# UNITED STATES PATENT AND TRADEMARK OFFICE

10/777,157

<b>Office Action Summary</b>	<b>Application No.</b> 10/777,157	<b>Applicant(s)</b> MAYAMA ET AL.	
	<b>Examiner</b> Terry L. Englund	<b>Art Unit</b> 2816

## **DETAILED ACTION**

FIG. 2

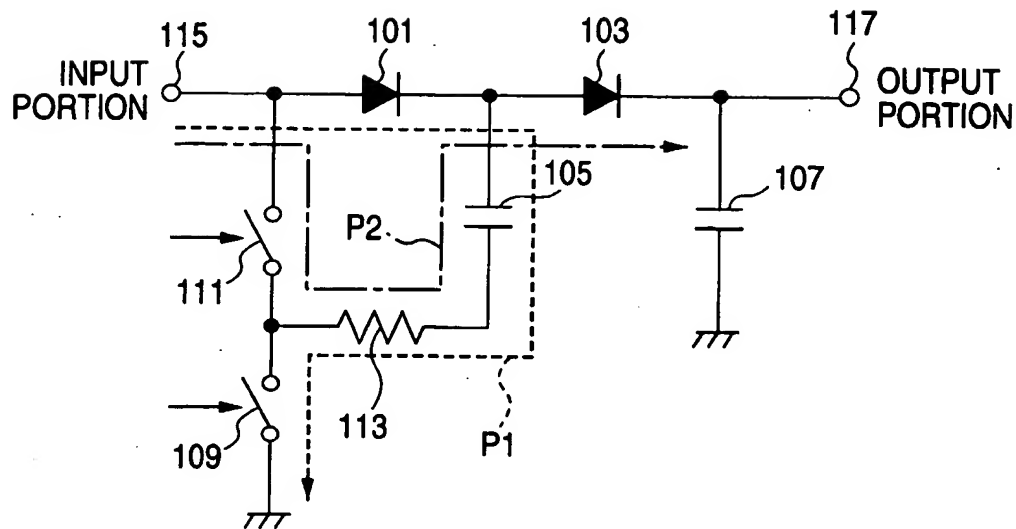
The drawing changes overcame the objections to Figs. 2, 4, and 5 as described in the previous Office Action. Therefore, those changes have been approved, and the drawing objections have been withdrawn.

The attached replacement drawing sheets makes changes to Figs. 2, 4 and 5 and replace the original sheets with Figs. 2, 4 and 5.

Approved  
11.2.05  
TLE
